April 24, 1985

RE: Mail Control 03574
Docket No. 030-21231

Please find enclosed, the additional information you requested to process our license application dated March 21, 1985.

A brief explanation of the changes I have made for Revision 1:

RADIOGRAPHIC EXPOSURE ROOM
(RADIO ISOTOPES)

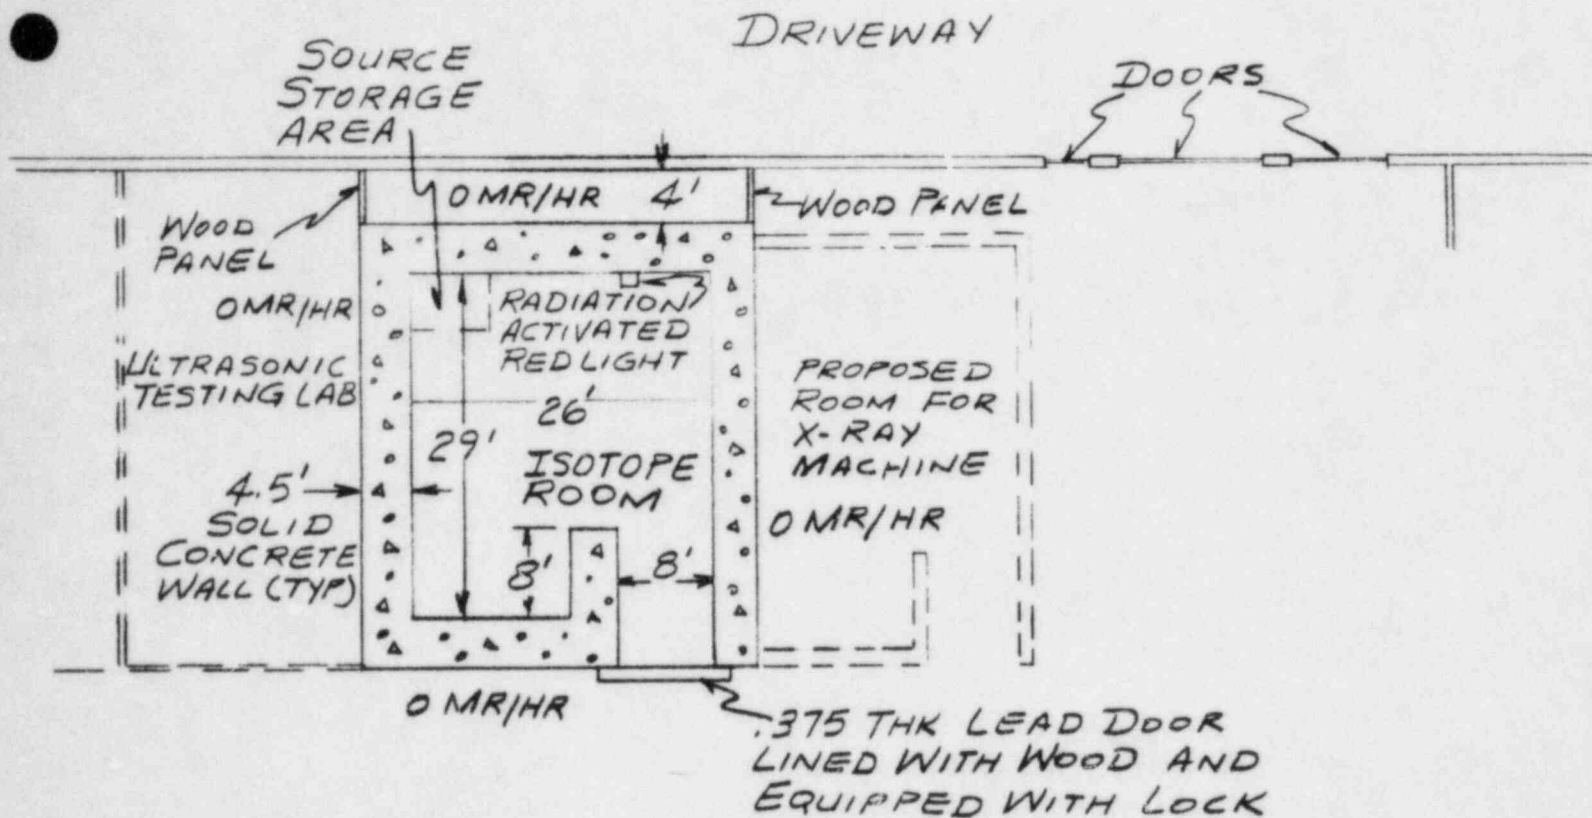
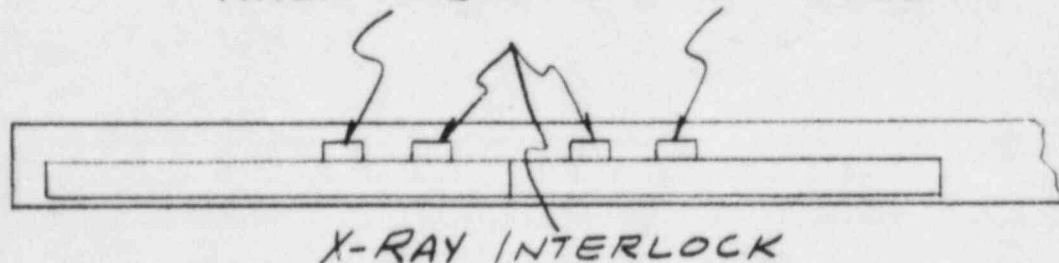
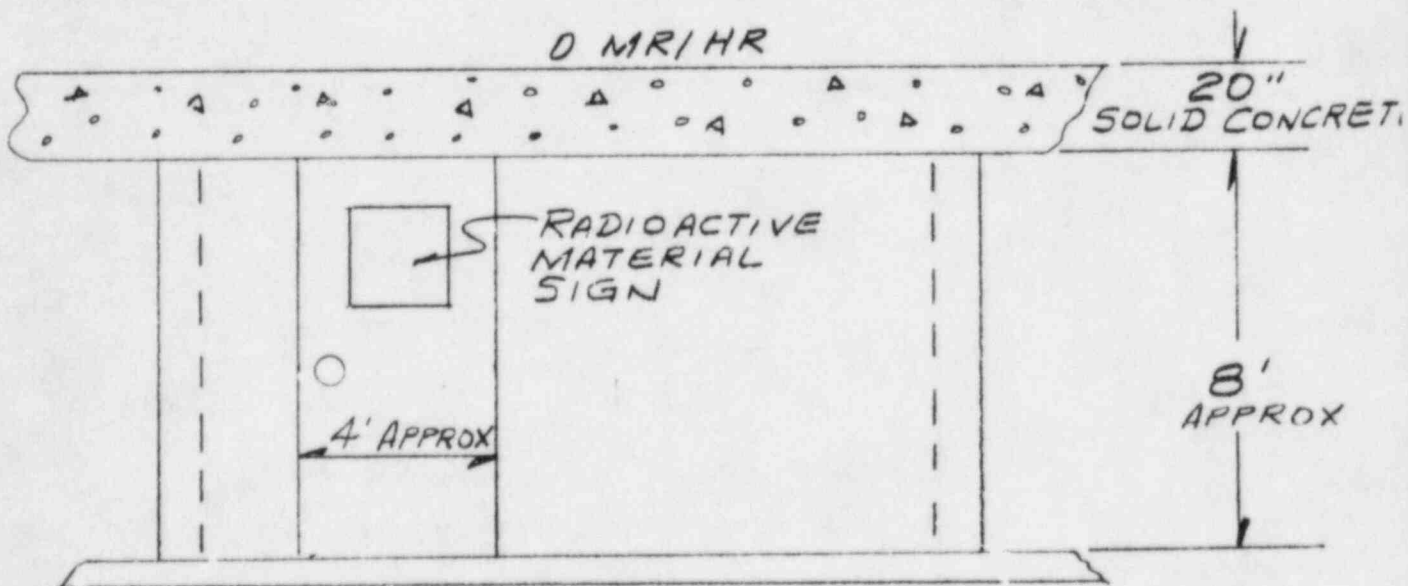
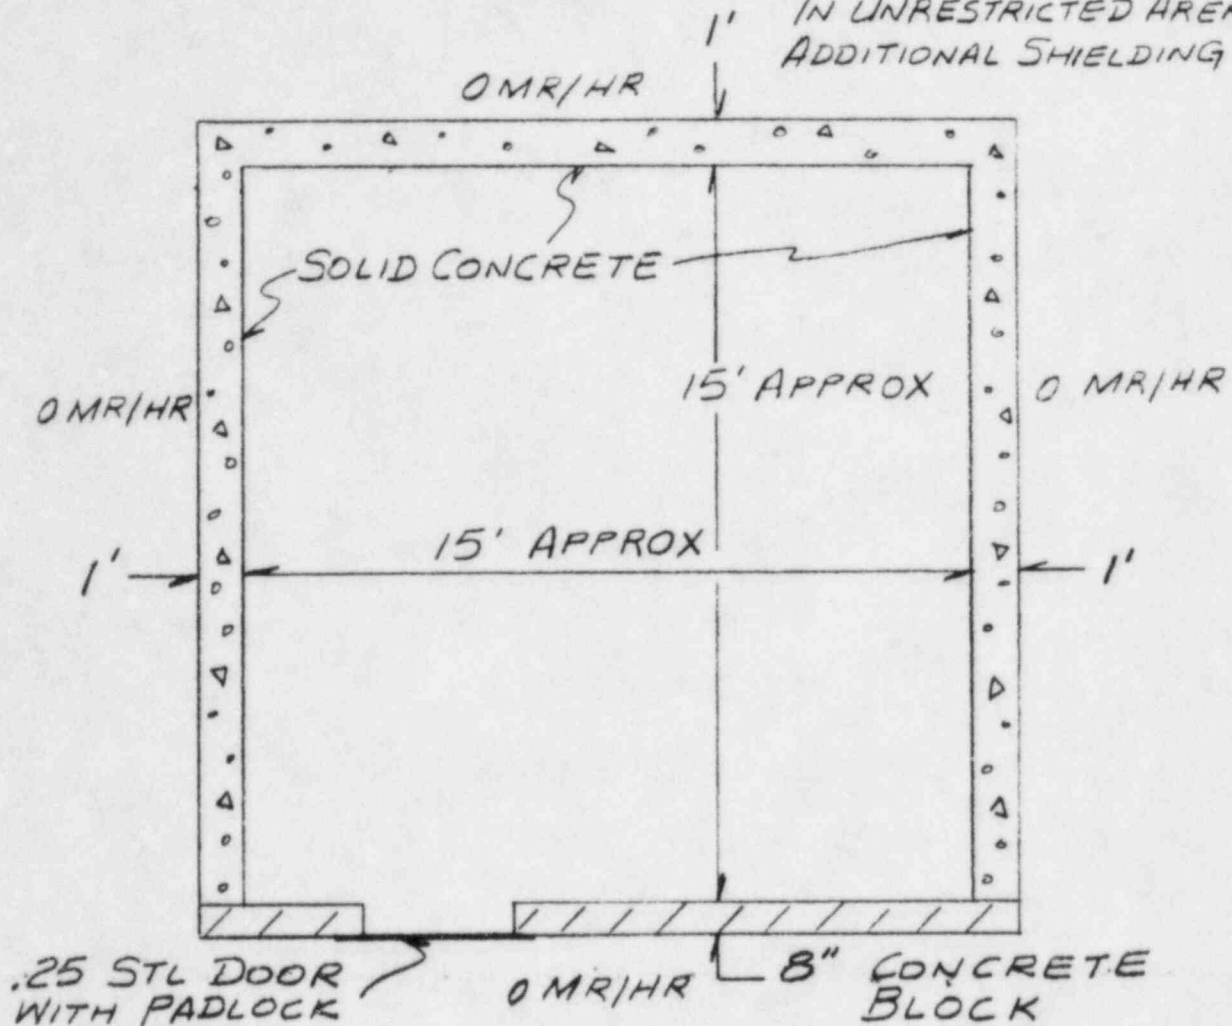
Page 9-1 thru 9-6 Added additional information requested on exposure room and storage vault
